Groundwater and Wastewater Services File Imaging Project

14801 Black Farms Road

Permit Number: 2275B

APPLICATION FOR IMPROVEMENT PERMIT
FOR RESIDENTIAL SITE
INDIVIDUAL WATER AND WASTEWATER
SYSTEMS PROGRAM

PLOT PLAN 2975 B = File #

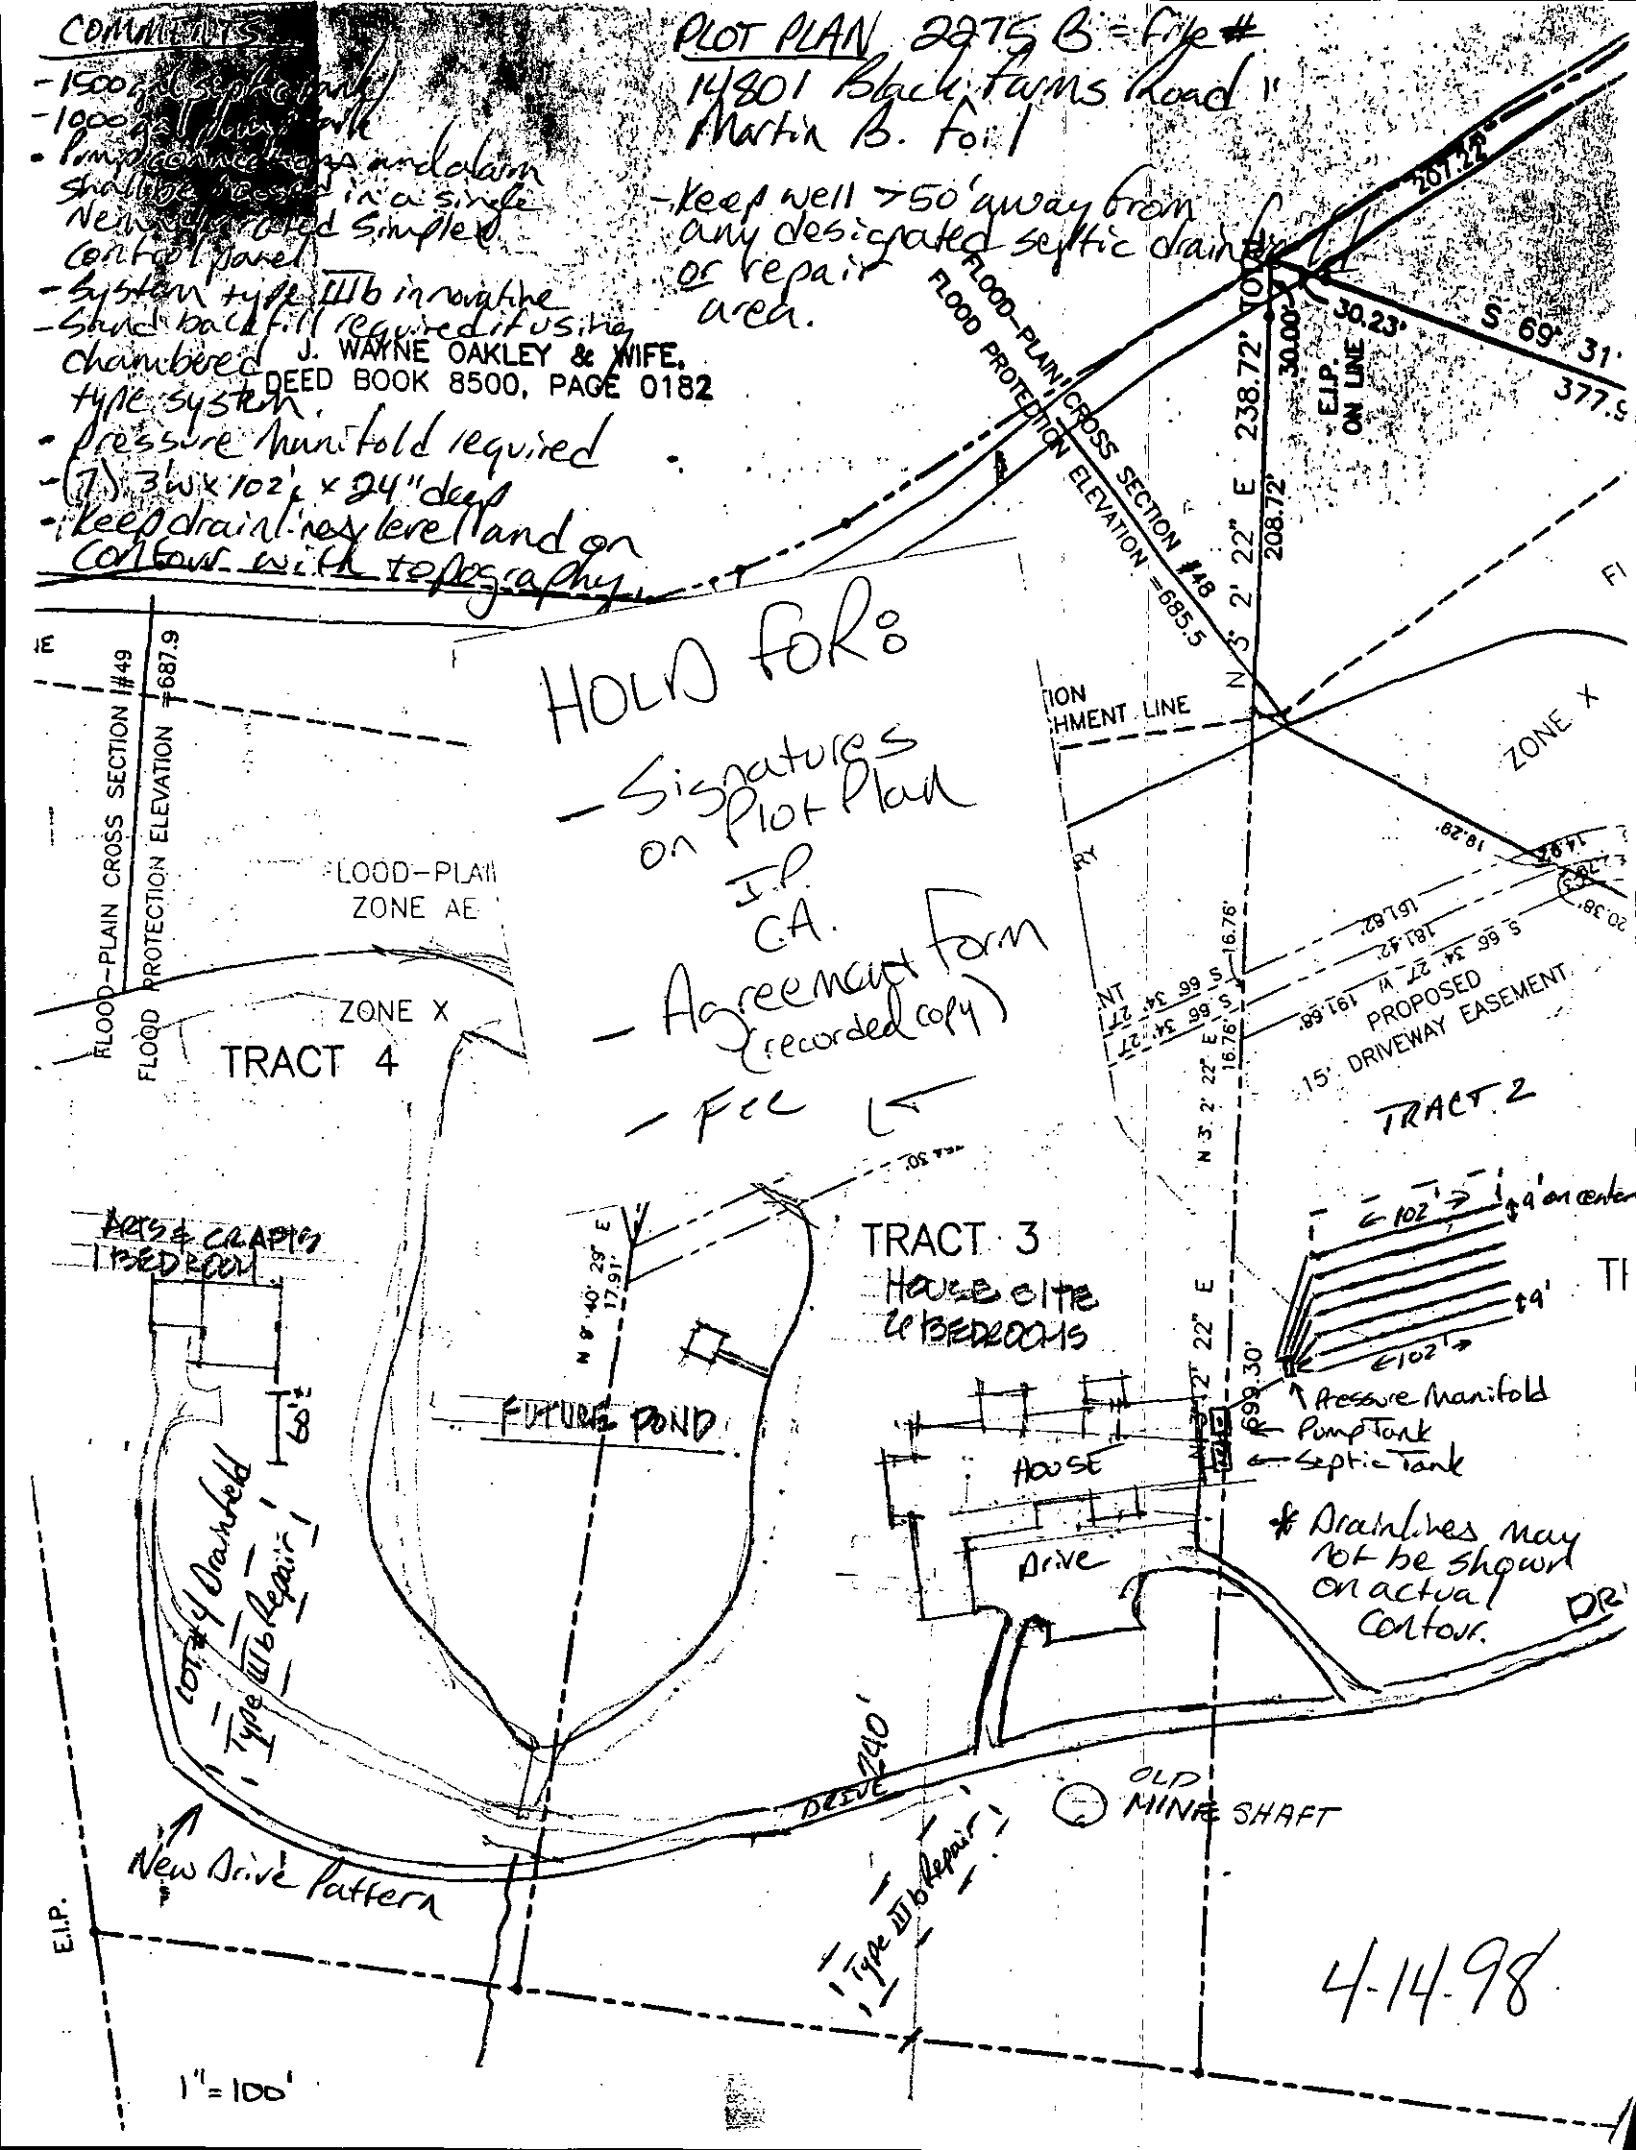
- 1500 gal septic tank
- 1000 gal dosing tank
- Pump, control panel and alarm shall be housed in a single NEMA type rated Simplex control panel
- System type IIIb innovative
- Sand backfill required if using chambered type system
- Pressure manifold required
- (7) 3' W x 102' L x 24" deep
- Keep drainlines level and on contour with topography

- Keep well >50' away from any designated septic drainfield or repair area.
